# HILLIARD PLANNING AND ZONING BOARD MEETING

TUESDAY, JUNE 13, 2023, 7:00 PM

**ITEM-2** Planning and Zoning Board Approval of Site Plan Application No. 20230119  
Oxford Pointe Multifamily Housing. Property Owner - Wayne Bishop  
Parcel ID No. 08-3N-2380-0063-0010.  
**Lee Anne Wollitz- Land Use Administrator**

# OXFORD POINTE

CONSTRUCTION ENTRANCE NOT TO SCALE

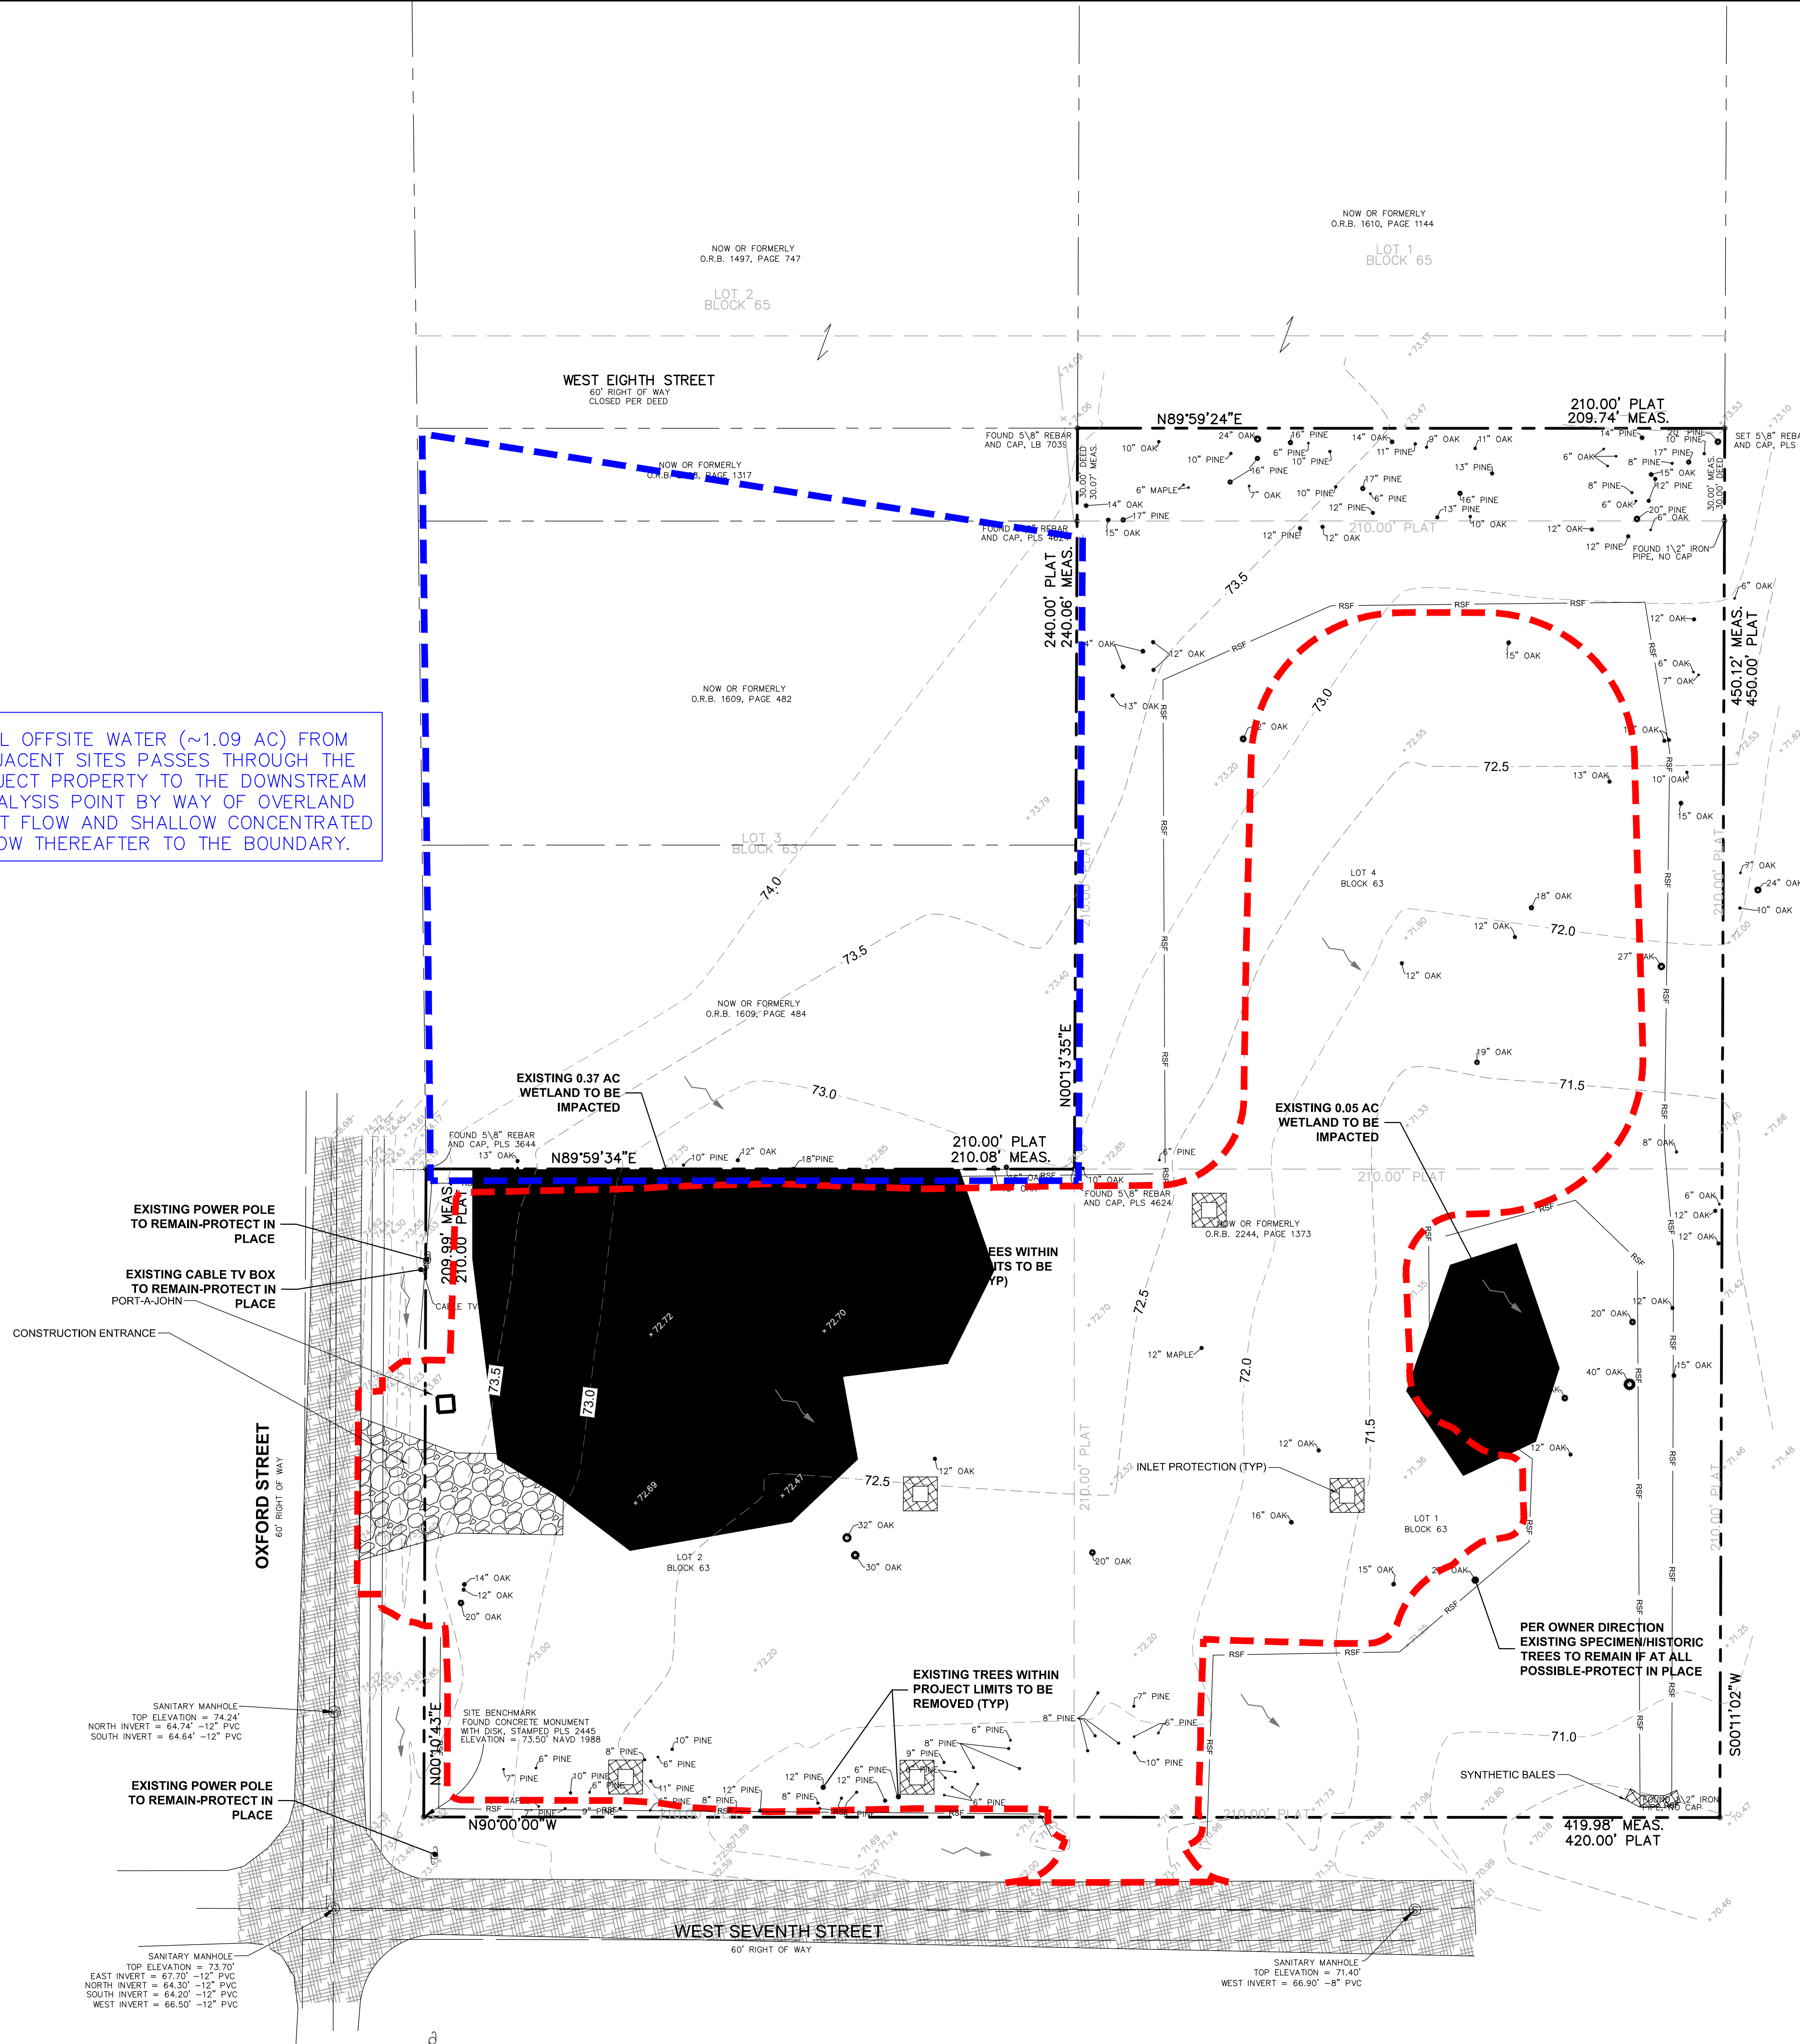
1. Provide a detail for the proposed Construction Entrance.  
**Construction entrance detail has been added to C2.0 Existing Conditions.**

**C3.0**  
 PROJECT NUMBER  
 2022-105

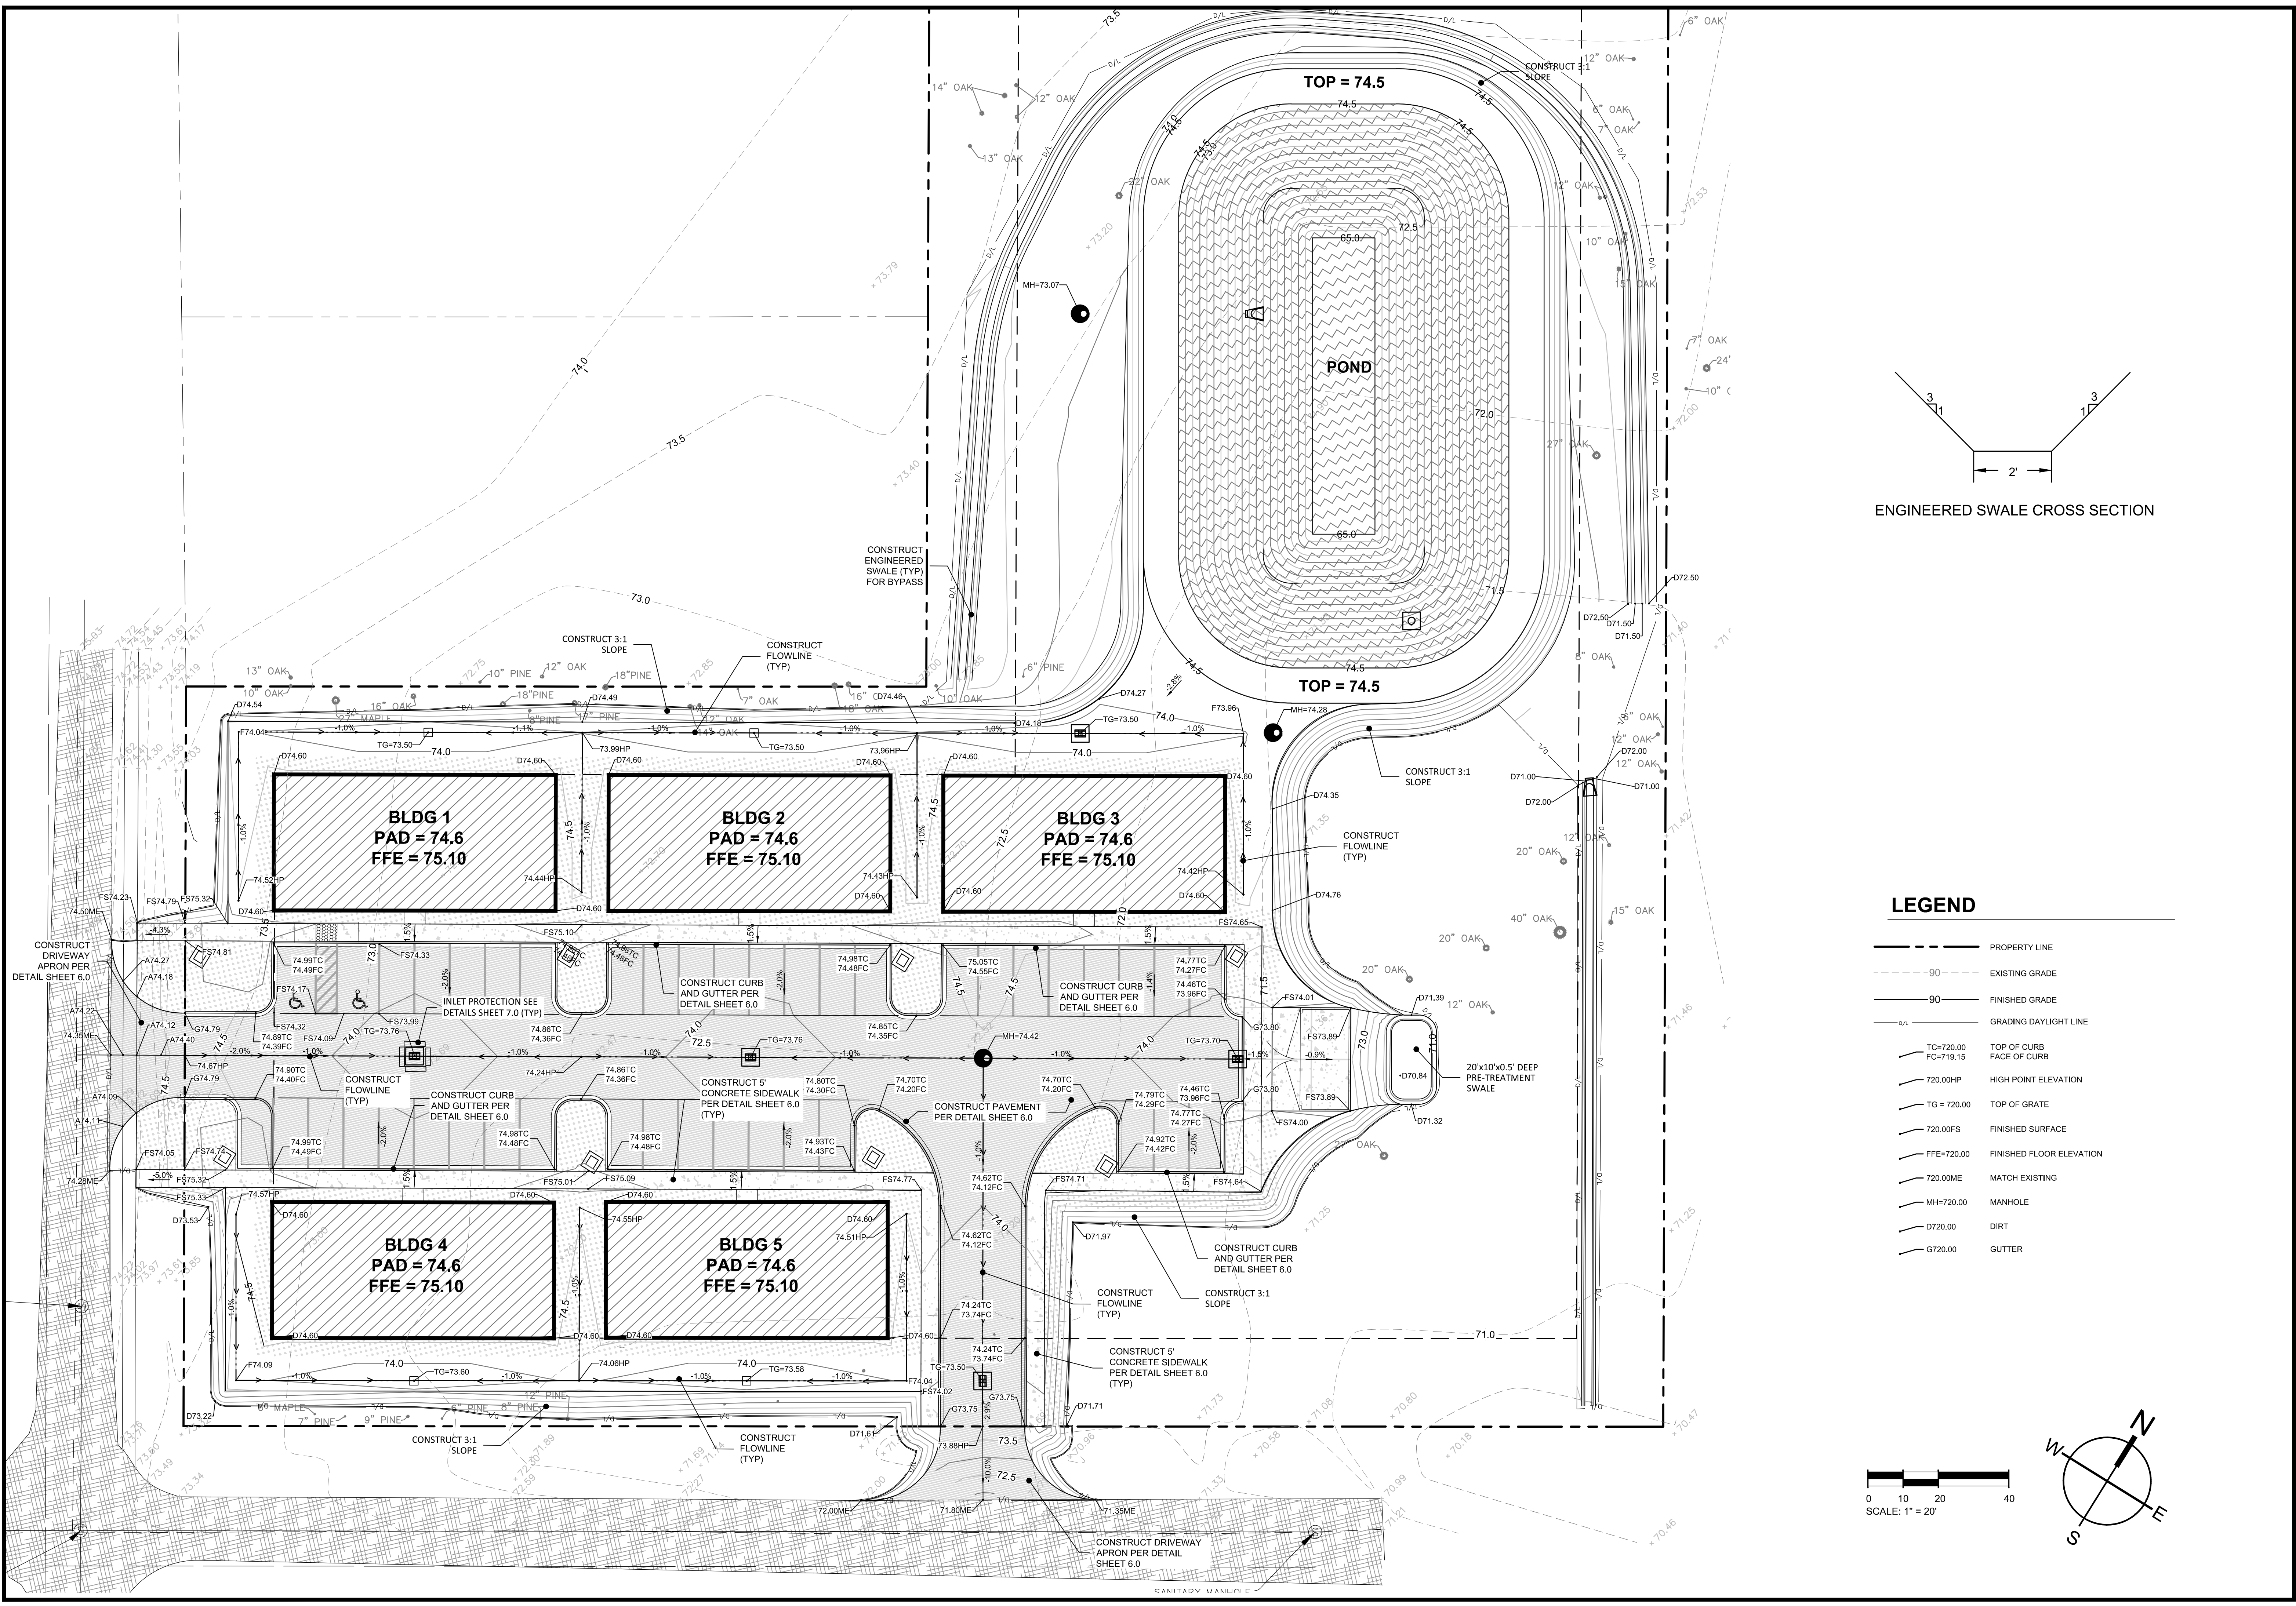
1. There are 39 STD Spaces and 2 ADA spaces displayed on the plan sheet. The two (2) displayed ADA spaces do not appear to have the same proposed width. Per LDR Section 62-382, a minimum of one (1) ADA space and forty (40) standard spaces will be required for the proposed development. ADA spaces will require a width of 12 feet. Revise the Drawing and Data Summary Table as applicable.  
**ADA Spaces and the Data Table have been updated on the revised C3.0 Site Plan. ADA Spaces are now both 12' wide with a 6' aisle. Additional space provided to match parking count (40 standard spaces).**

1. The zoning of the property is R-3. The applicant has not submitted an application for rezoning. The note on Sheet C3.0 related to "Proposed Zoning" needs to be deleted. A permitted use in the R-3 zoning district is multi-family development.  
**Noted. The data table has been updated.**
2. The development needs to have a minimum of 40 parking spaces, 2 of which must be handicapped accessible. The site plan proposes 40 parking spaces of which 2 are handicapped accessible, but the handicapped spaces do not meet the Florida Building Code, which requires the spaces to be a minimum of 12 ft. wide. The site plan indicates the spaces are 9 ft. wide. The site plan needs to be revised to meet the minimum size of the Florida Building Code.  
**The parking has been updated to consist of 40 spaces and 2 ADA sized at 12' wide each.**

The Future Land Use Map designation for the property is MDR, Medium Density Residential. The Future Land Use Map designation MDR, Medium Density Residential needs to be added the Sheet C3.0

The zoning of the property is R-3. The applicant has not submitted an application for rezoning. The note on Sheet C3.0 related to "Proposed Zoning" needs to be deleted.
